REV.
B

AS3140

(R) STUD, STEPPED - 2.5 DIA ENGAGEMENT, PD SHANK, AMS5731
.3125-24 UNJF-3A X .2500-28 UNJF-3A

AS3140
SHEET 1 OF 2

FIGURE 1

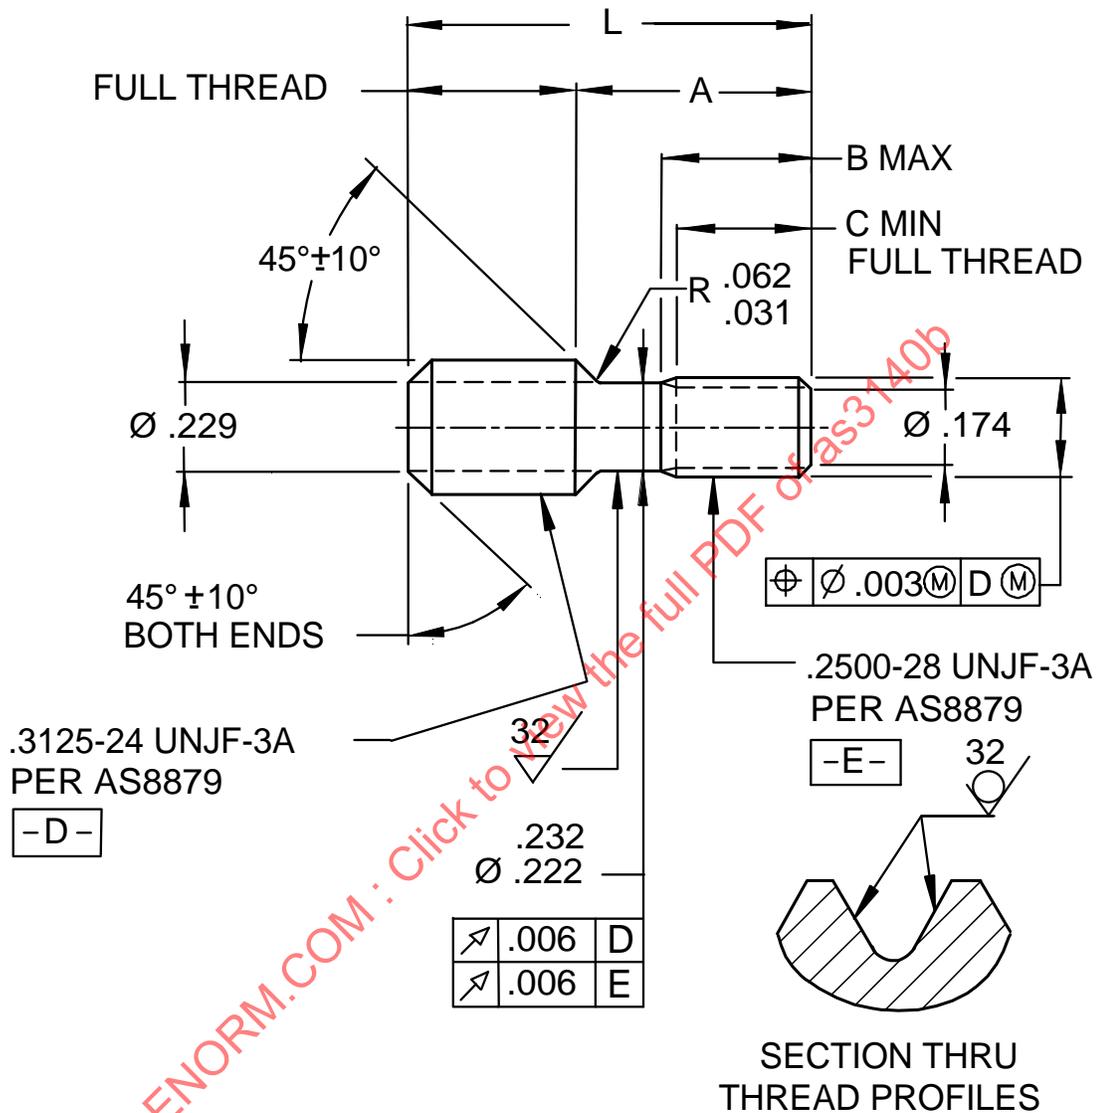
REVISE THREAD SPECIFICATION TO AS8879, UPDATE FPI REQUIREMENTS, REDRAW TABLE TO DELETE METRIC DUAL DIMENSIONING, REFERENCES UPDATED WHERE REQUIRED.
